Project Name: Nuneham Solar Farm

Report Name: Response to Flood Risk & Drainage Objections

Project Number: P21-2947

Updated Surface Water Drainage Strategy Drawing

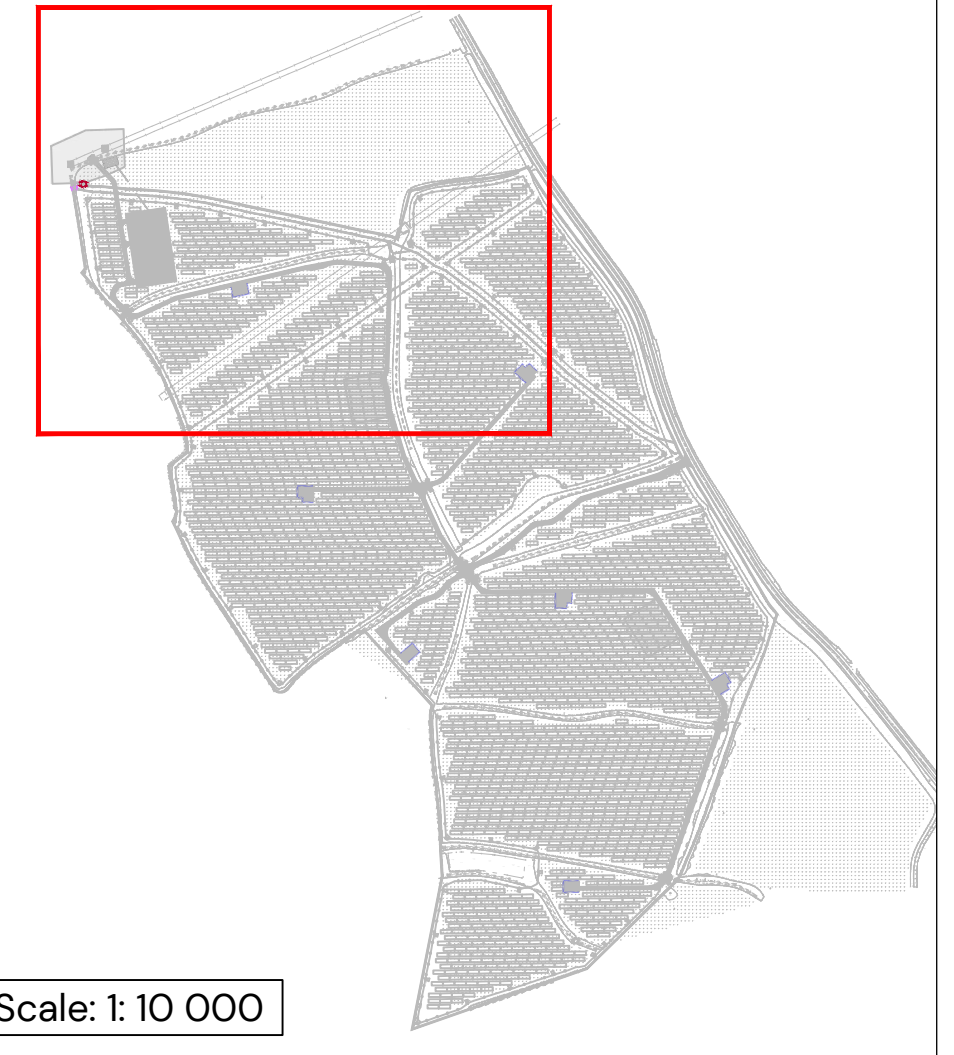
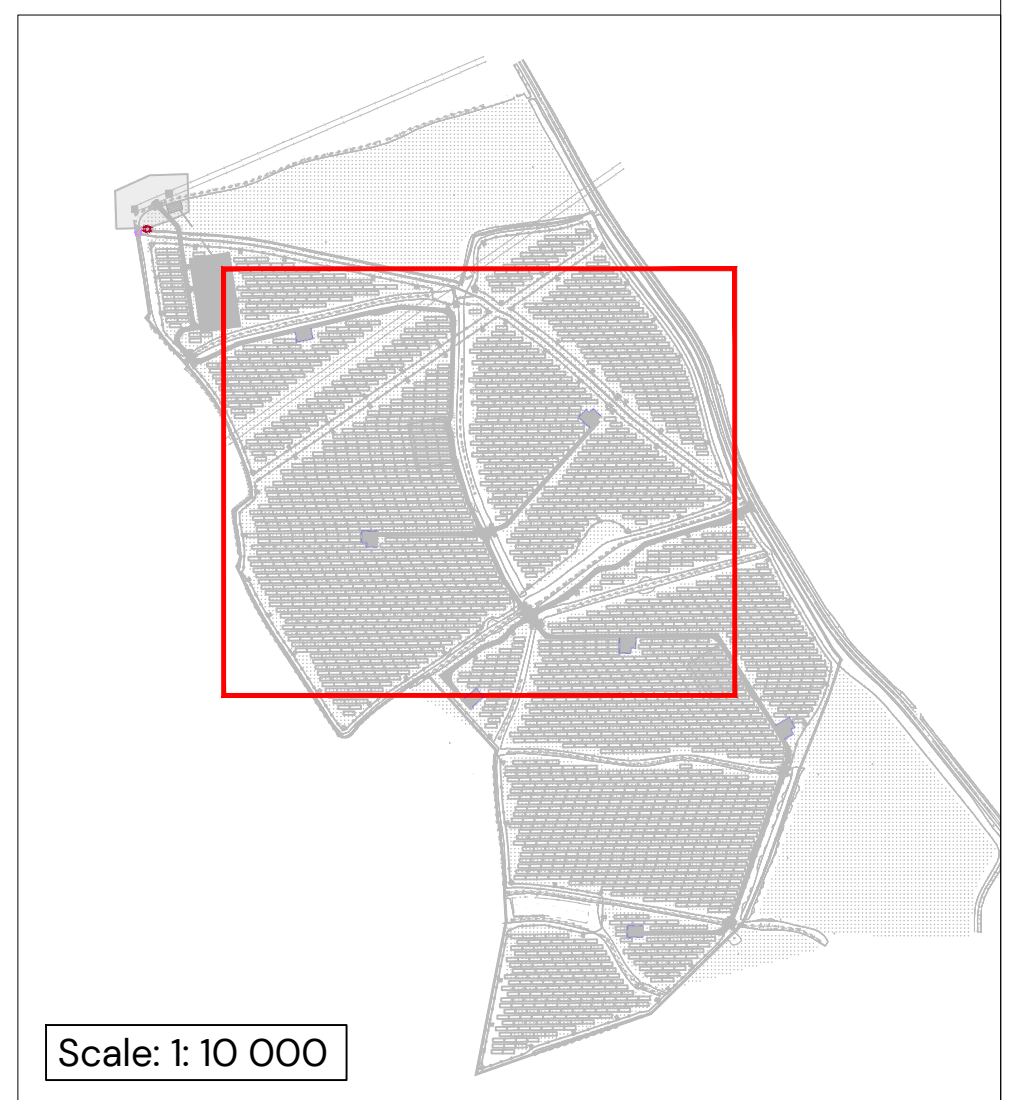
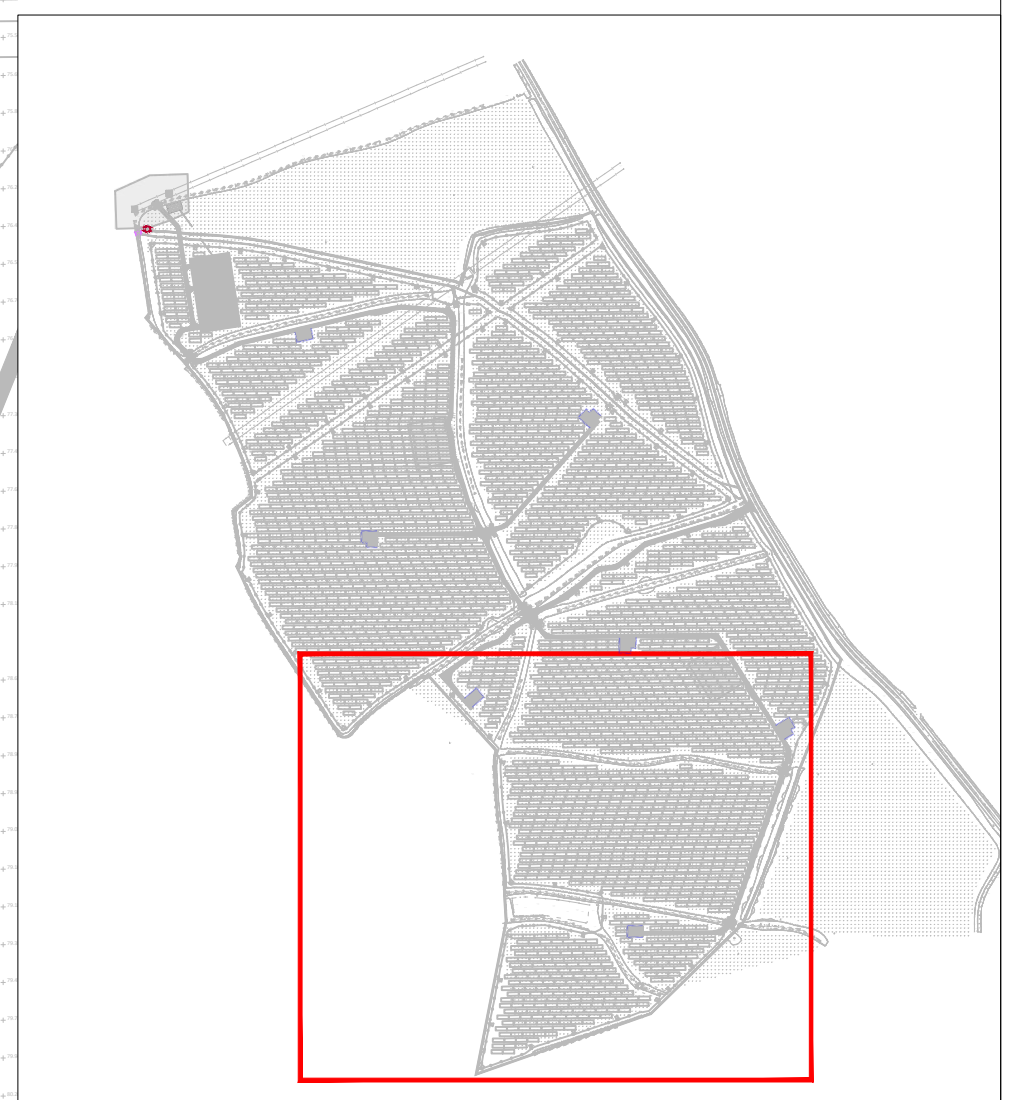
In their comments which are enclosed at the end of this document, the council have stated that "incorrect Cvs have been used" and advised that the submitted surface water drainage strategy should be "corrected in line with the Oxfordshire Flood Toolkit, Local Standards and Guidance for Surface Water Drainage on Major Development in Oxfordshire, Appendix D, Page 35". These standards state that "when running calculations, the LLFA expect Cv values should be set to 0.95 for roofed areas and 0.9 for paved areas".

South Oxfordshire and Vale of White Horse District Council drainage team have stated that “swales have been discussed within the text to drain access tracks, but no reference to these on the drainage strategy drawing is provided”.

Following these comments, all MicroDrainage calculations have been updated to include a Cv value of 0.95 and the submitted surface water drainage strategy has also been updated to reflect the increased storage requirements based on this higher Cv value. The updated surface water drainage calculations and associated surface water drainage strategy drawing are enclosed at the end of this document.

Typical Access Track Detail

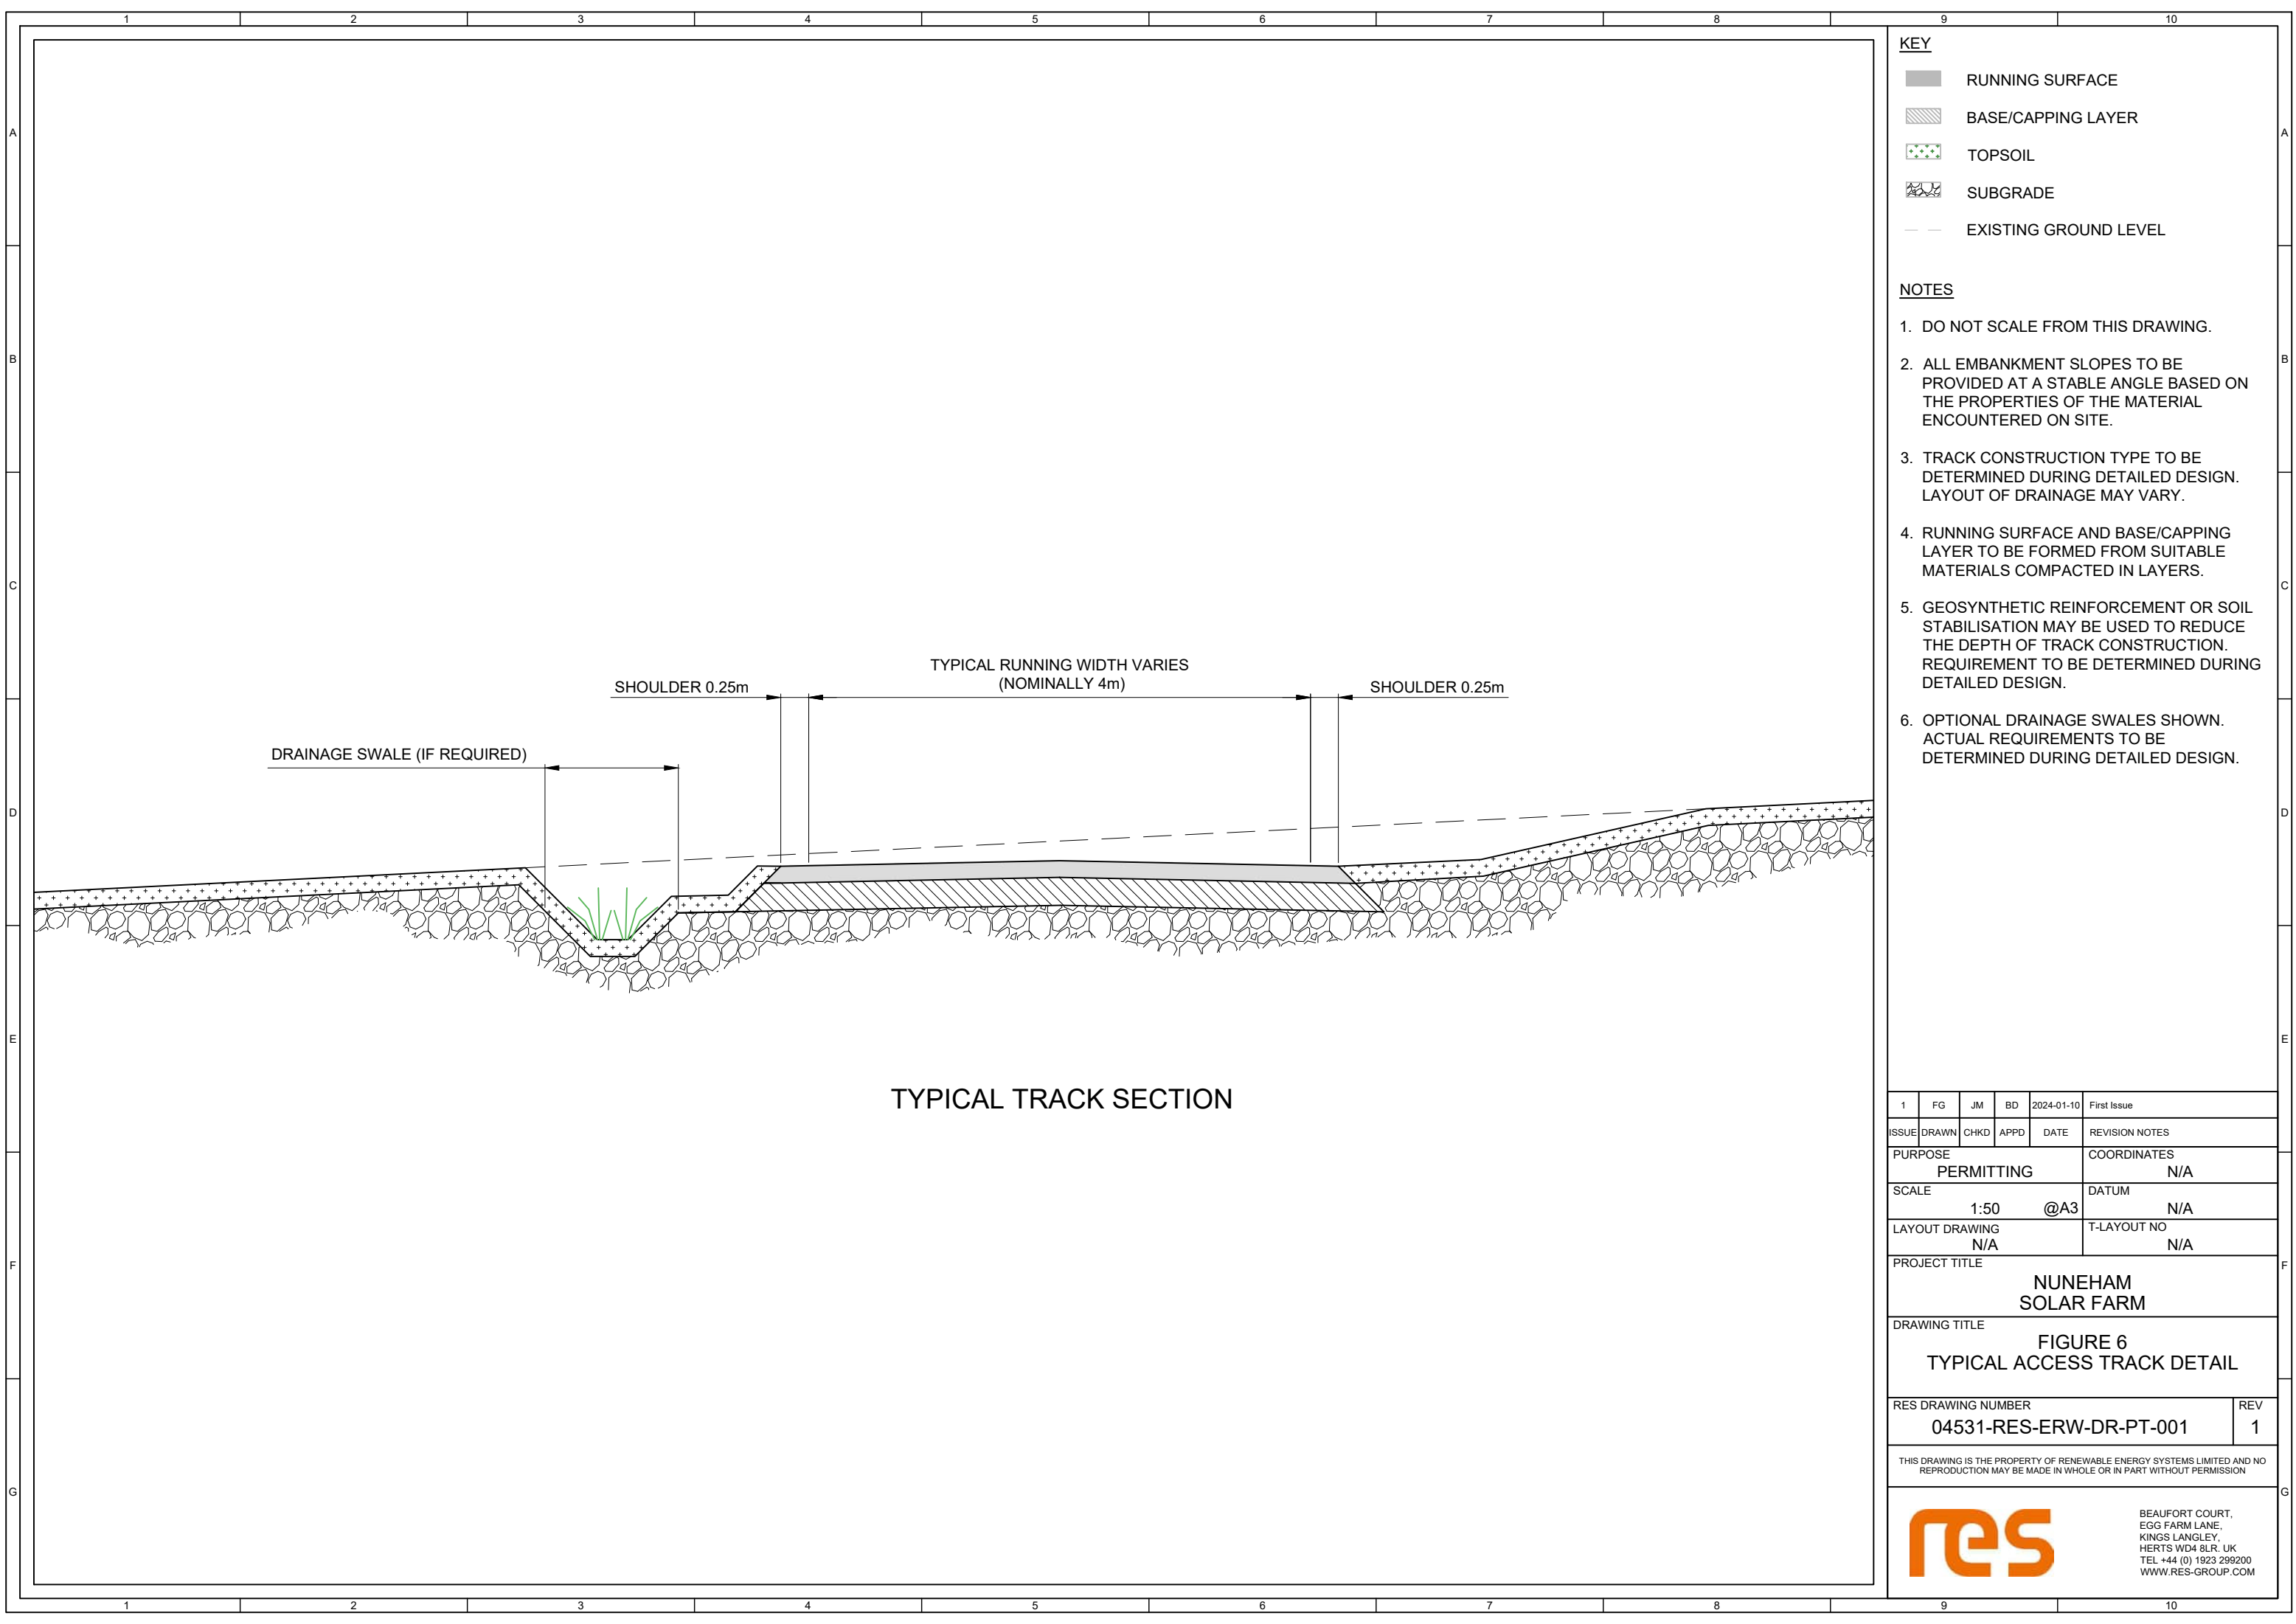
Swales have been discussed within the text to drain access tracks, but no reference to these on the drainage strategy drawing is provided.

All access tracks on site will have a swale alongside them. A typical access track detail for the site is enclosed at the end of this report. It’s noted on this enclosed plan (Figure 6), in reference to the swales, that “actual requirements” will be “determined during detailed design”. In addition to the typical access track detail enclosed at the end of this report, a “Proposed Swales” plan has also been prepared and is enclosed at the end of this report. This plan highlights the access tracks across the site where swales will be provided. The plan also shows several additional swales proposed on site where it has been identified there was not an access track and associated swale at the downslope end of blocks of solar arrays. The proposed swales will help capture and infiltrate and surface water runoff from the site.
